**Generic Design Assessment – New Civil Reactor Build**

**GDA Close-out for the EDF and AREVA UK EPR™ Reactor**

**GDA Issue GI-UKEPR-SI-01 Revision 2**

Assessment Report: ONR-GDA-AR-12-005

Figure 2. Original and optimised U-leg design (from Ref. 61)

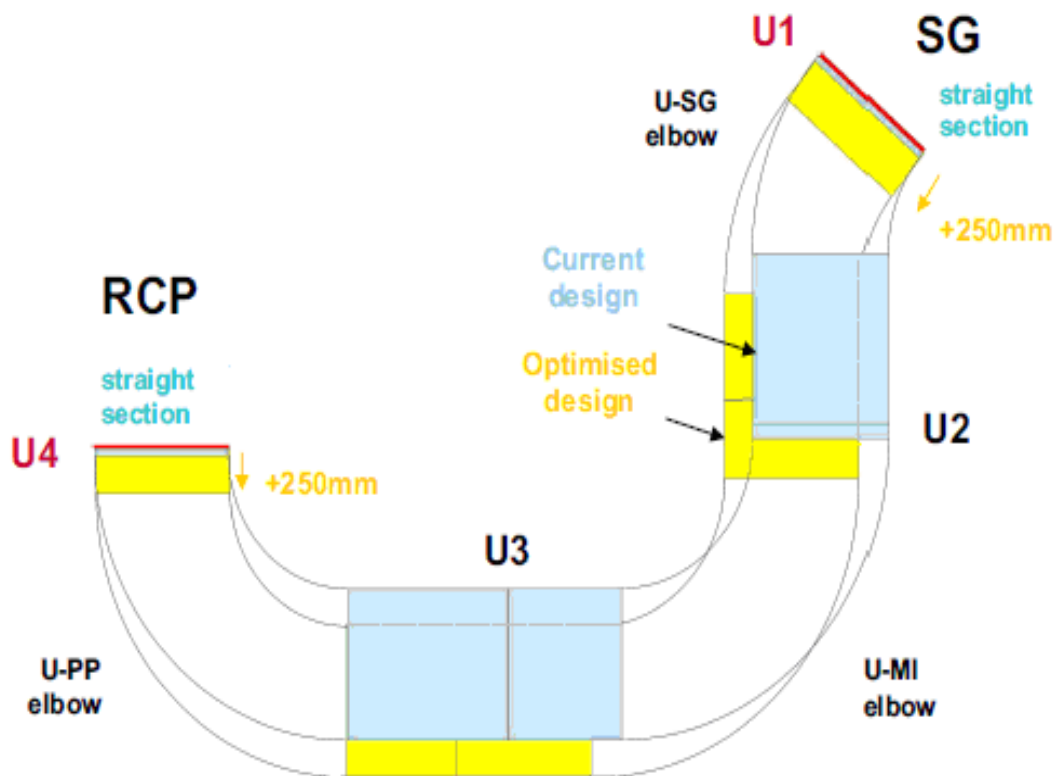
- Any ripples that happen to be generated by the induction bending process are now well removed from the weld location. This improves the fit-up achievable at the weld, facilitates a better surface profile at the weld and ensure the ripples caused by bending do not interfere with scanning the ultrasonic probes.
- The longer straight section allows optimum scanning of the welds as well as easier fit-up of the manipulator for these automated inspections.
- Since the induction bending occurs away from the ends of the forgings the manufacturing process is easier.

In addition to the increased straight sections at the ends joined to the SG and RCP, the position of the intermediate weld (weld U2) has been adjusted to improve the straight sections available for ultrasonic inspection on the 90° elbow. The position of weld U3 has been adjusted to assist forging of the U-PP elbow which is the largest of the three forgings of the U-leg. This change has also been progressed via the change management process under UKEPR-CMF-031 (Ref. 100) and is now at Stage 3 ready for handover to the site-specific phase.

Figure 3. Main Steam Line Weld Preparation Details (from Ref. 69).

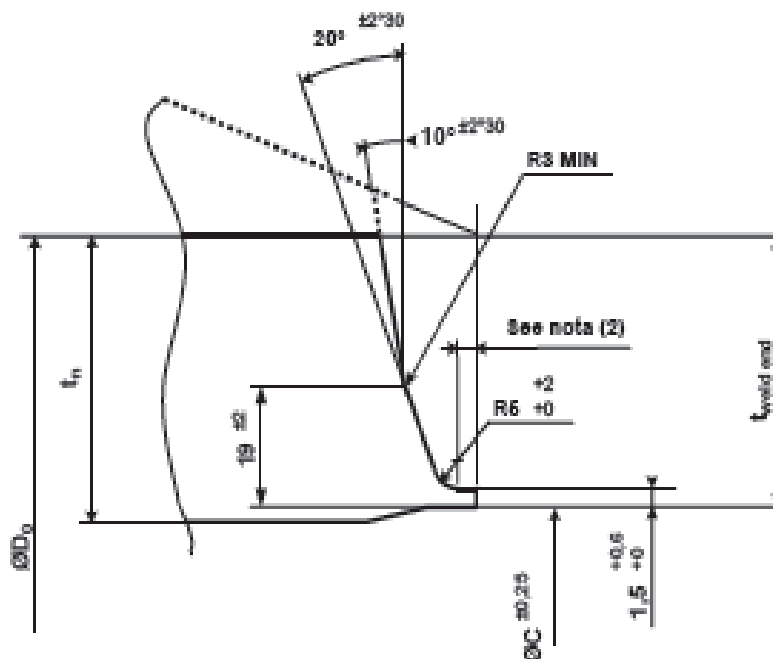
355 As shown in the weld preparation MSL cross-section below, the standard weld preparation has two slopes; at 20° from the root up to 19 mm from the bore, and at 10° thereafter.

Consequently for the thinner welds of about 30 mm thickness the weld preparation angle will be predominantly at 20° whereas, for the thicker welds, the 10° section becomes greater. Hence the achievement of near-specular reflection throughout the weld generally becomes more difficult with increasing weld thickness and this is the case for weld 12 which is a pipe to 90° elbow weld outside the reactor building and is discussed below.

**Figure 4. Geometry of Welds 10 and 11 between the MSL pipework and the MSIV  
(from Ref.71)**

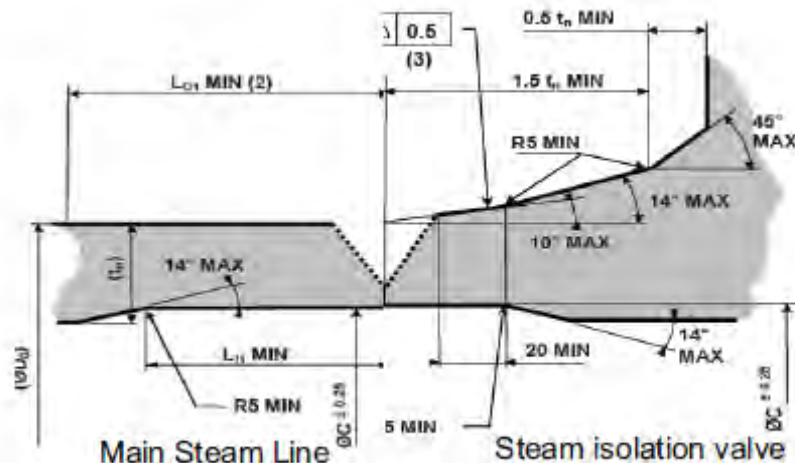
357 Ref. 69 describes all the HIC welds including those to the main steam relief valve (MSRV) and the main steam safety valve (MSSV). Following my review of these welds, I am generally satisfied with the coverage achievable on those which can be inspected from both sides, but those with only single-sided access merit further consideration. These are welds 10 and 11 which relate to the MSIV, welds 12 and 14 which connect straight pipe sections with 90° bends, and the MSRV and MSSV attachment welds. The locations and geometries of these welds are described more fully in Ref 69, but the figure below shows the geometry for welds 10 and 11 between the MSL pipework and the MSIV.

358 For those welds with single-sided access, the least favourable angle of incidence on any weld fusion face is generally 20° and occurs for the outer 10° section of the fusion face nearest to the scanning surface. However in the case of weld 12 (40 mm thick) the 60° beam at full skip is 30° from normal on the outer 10° section which is approximately 50% of the weld thickness. A similar misorientation of 30° occurs for the MSRV and MSSV welds but since these are only about 25 mm thick there is only about 6 mm of fusion face affected. Corner effects may improve defect detection, especially for the thinner welds, and some support for this is provided by modelling of the MSSV. I judge that detection of smooth planar defects on the least favourable fusion face of weld 12 may be possible via a mode conversion or a corner echo but that will need to be demonstrated during the

**Figure 6. RT Simulation modelling using Pollitt theory (from Ref. 78)**

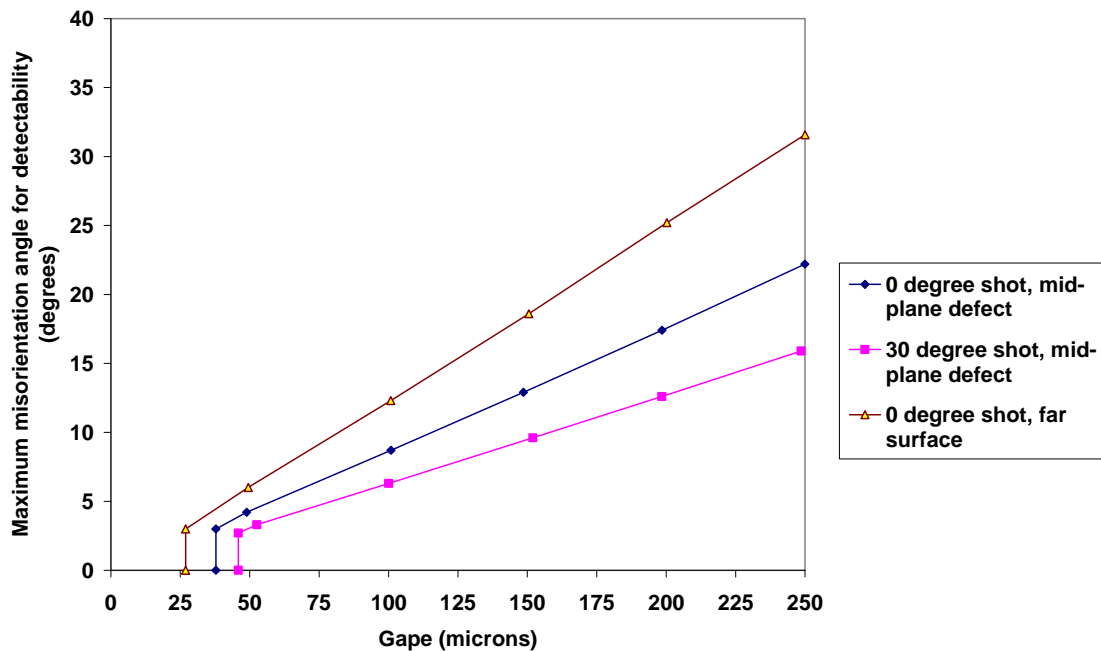
387 There are three cases of  $30^\circ$  misorientation and all involve lack-of-fusion defects which were detected. Of these, two cases have the defects on the far side (favourable for detection) and in one case the defect is on the near side. The Pollitt calculations by Serco (see Figure 6 below) suggest that a gape of  $>250 \mu\text{m}$  would be needed to achieve detection when  $30^\circ$  misaligned, even for a defect on the far side. This suggests that either the defects are wider than the example lack-of-fusion defect in Appendix 2 or there are volumetric features associated with them. However TQ-EPR- 1464 response to Question 3 states that there are no volumetric features in the radiographic images of the defects. At a meeting on 20 October 2011, EDF and AREVA said that the defects were still visible at  $30^\circ$  misorientation although the defect indications were broader and typically 4 mm wide.

388 I conclude that the RT demonstrated a good capability to detect the planar defects in the mock-up even with shots not aligned with the weld preparation angle. Unfortunately some of the characteristics of the defects which affect their detectability are inevitably very uncertain since the mock-up has not been destructively examined. The good detection rate with RT may be a result of the defects having relatively wide gape.
